STEREO HI-FI
SUPPLEMENT 1 TO
BULLETIN R53-3,-4,-7,-8

MODEL: MS3722

CHASSIS: R53-4

CODE CHANGES
R53-3,-4,-7,-8

Figure 1

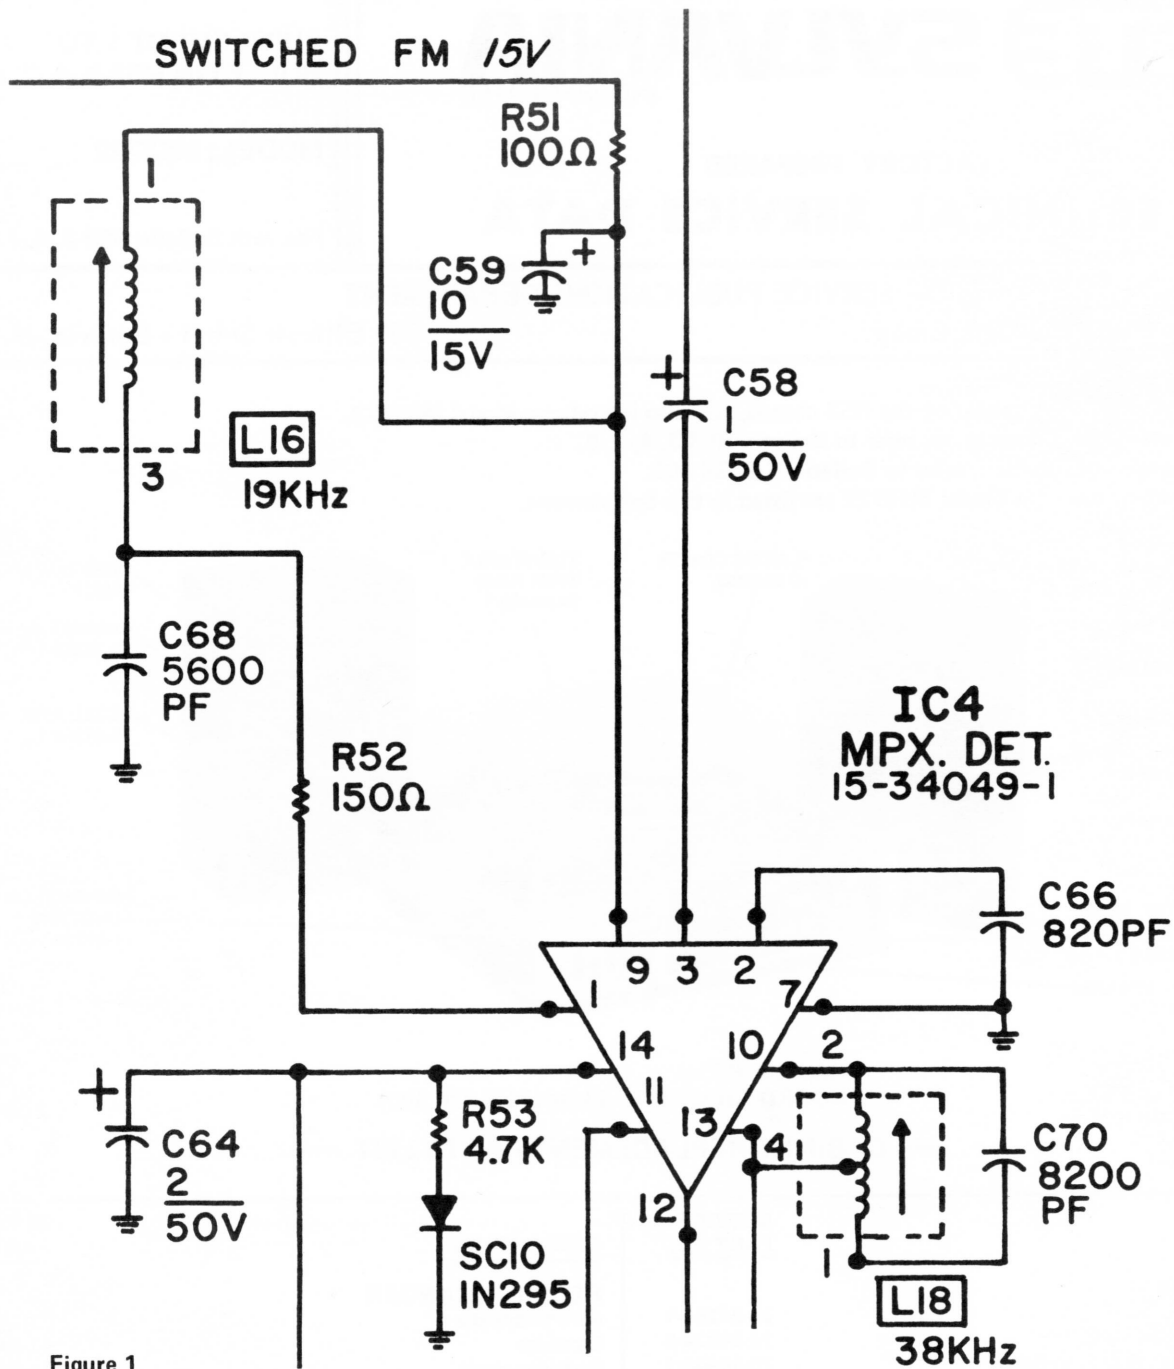
CODE 05:

REASON: Stereo operation becomes inoperative when tuning into signal.

DESCRIPTION: The following changes were made:

1. 19kHz coil (L16), pin 1, connected directly to pin 9, IC4.
2. R51 (100 ohm) resistor added.
3. C59 (10MFD/15V Electrolytic) added.
4. R52 changed from 1K variable to 150 ohm fixed resistor.

SEE FIGURE 1
